### PUBLIC NOTICE CITY OF BEXLEY ARCHITECTURAL REVIEW BOARD

Application No.: ARB-20-22 Applicant: Jeremy Clifton Owner: Christopher and Jenny Dersom Address: 175 S. Roosevelt ARB Request: The applicant is seeking architectural review and approval, to allow a 2story addition to the rear of the principal structure and window replacement.

### ARB-20-22

2017 LOCATION SURVEY SCALE: NTS

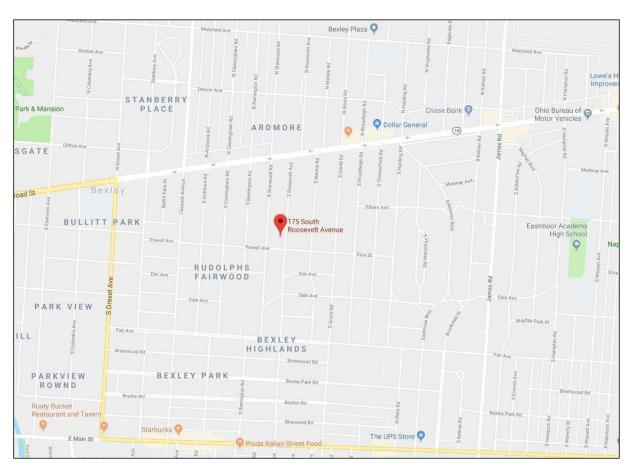
what is the distance from the south side property line and the addition? if less than 8' it will require a BZAP appliction instead of an ARB

The survey indicates 7.2' which means it's a variance regardless of what the existing setback is. We did add a code section that allows an addition, if it is held back 8", which in this case would put you back at 8', Let me know what you want to do. **Jeremy Clifton** March 27th 2020, 4:39:53 pm

Got it! We do not want to go for a variance so we will hold the addition back a minimum of 8" to reach the minimum 8' set back. Please let me know what you need from me if anything to proceed with this. Hard copies will be dropped off Monday.

Hi Kathy/Robin - I just uploaded the new stamped drawings indicating the minimum 8' set-back. Please let me know if you need anything else for ARB.
